Recommended Standards for Implementation of RNP Approach (RNP APCH) Operations Including an Extended Visual Segment

PARC Navigation Working Group

RNAV (GPS) Z RWY 13L

Figure 1.

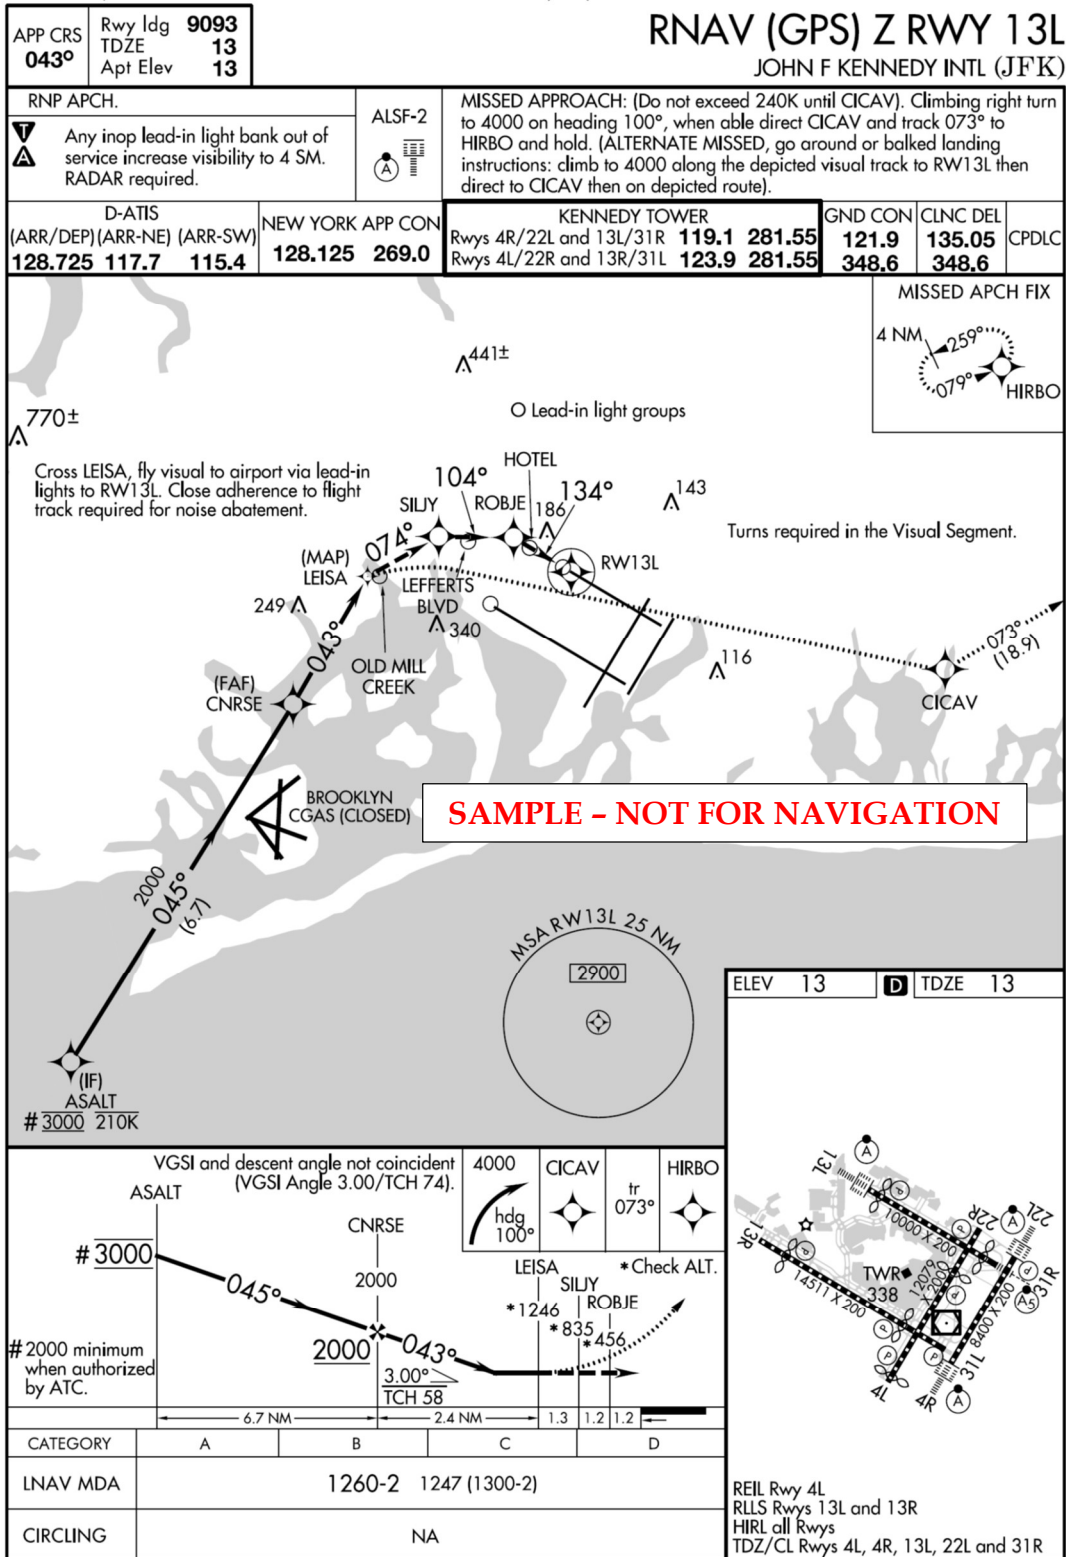
Discussion: The new *RNAV (GPS) Z RWY 13L* at JFK established the published MAP at the end of the procedure’s instrument segment (reference LEISA (MAP) in Figure 1.). The placement of the MAP at this waypoint intends to support aircraft operating at JFK that have either aircraft or avionics limitations requiring the flight crew to disengage the aircraft’s autopilot and/or flight director when proceeding beyond the MAP and descending below the MDA. The aircraft with these limitations also often lack continuous LNAV should

the flight crew elect to begin a missed approach. However, while intending to provide a means for the aircraft to offer advisory lateral and vertical guidance in the visual segment, placing the MAP at this waypoint caused confusion for operators of aircraft with continuous LNAV, aircraft and avionics manufacturers and navigation database providers. This confusion led to FAA accepting alternative database coding locating the MAP at the RWY 13L threshold and an update offering new wording for the procedure missed approach instructions including new “ALTERNATE MISSED” instructions (reference Figure 1.).

Discussion: One of the most confusing elements of the RNAV (GPS) Z RWY 13L procedure implementation has been the published MAP and flight crew concern about the actions they should take when operating in the extended visual segment and need to abandon the effort to transition to land (for any reason). The original missed approach instructions confused pilots, and repeatedly pilots questioned the FAA team on the actions the ATC expects should they abandon the procedure at or beyond the procedural MAP. While the addition of “ALTERNATE MISSED” instructions helped quell pilots’ concerns, standards for conducting future RNP APCH with an extended visual segment should include guidance on expected pilot response when a need arises to abandon the procedure from any point on the procedure from the IAF inbound.

Discussion: The RNAV (GPS) Z RWY 13L procedure relies on the pilot use of the lead-in lights to RWY 13L as a visual reference enabling continuing the approach operation beyond the Visual Guidance Fix (VGF), identified as LEISA in Figure 1. Yet, operator and pilot confusion exists with the use of lead-in lights as part of compliance with CFR Parts 91.171 and 91.175. While the current Airman's Information Manual (AIM) offers some clarity on use of lead-in lights in a manner consistent with their intended use at JFK RWY 13L, the guidance is not clear and consistent with in the AIM. Nor do any other guidance documents offer necessary clarity.

Recommendation: FAA should standardize the location of the procedural MAP for all RNP APCH procedures with an extended visual segment and place the MAP at the threshold of the landing runway. This should occur through an update to FAA Order 8260.58() as part of a larger update to embrace procedure design criteria for an RNP APCH with an extended visual segment, including an extended visual segment requiring turns for runway alignment.

Recommendation: The FAA should distinguish the RNP APCH with an extended visual segment by a new, specific identification of the waypoint defining the end of the instrument operation and beginning of the extended visual segment. The PARC Nav WG recommends this waypoint ID become the Visual Guidance Fix (VGF). RNP APCH procedures with an extended visual segment should chart the procedure with the acronym "VGF". The FAA should also provide guidance describing the VGF as the waypoint where the pilot must make a decision that adequate visual references permit continuing the approach by following the RNP system's advisory lateral and vertical guidance in the extended visual segment when the aircraft's begins the fly-by transition at the VGF.

Recommendation: To better facilitate implementation of RNP APCH procedures with an extended visual segment, the FAA should expand and clarify the guidance on pilot use of lead-in lights as a visual aid and reference during transition to an extended visual segment enabling compliance with CFR Parts 91.171 and 91.175. The FAA should also standardize to the extent practical the impacts inoperative lead-in lights may have on the visibility requirements for each RNP APCH with an extended visual segment. FAA should then ensure procedure design standards for an RNP APCH with an extended visual segment define the increased visibility requirements for conduct of the approach with the lead-in lights inoperative, using the example provided by the RNAV Z (GPS) RWY 13L.
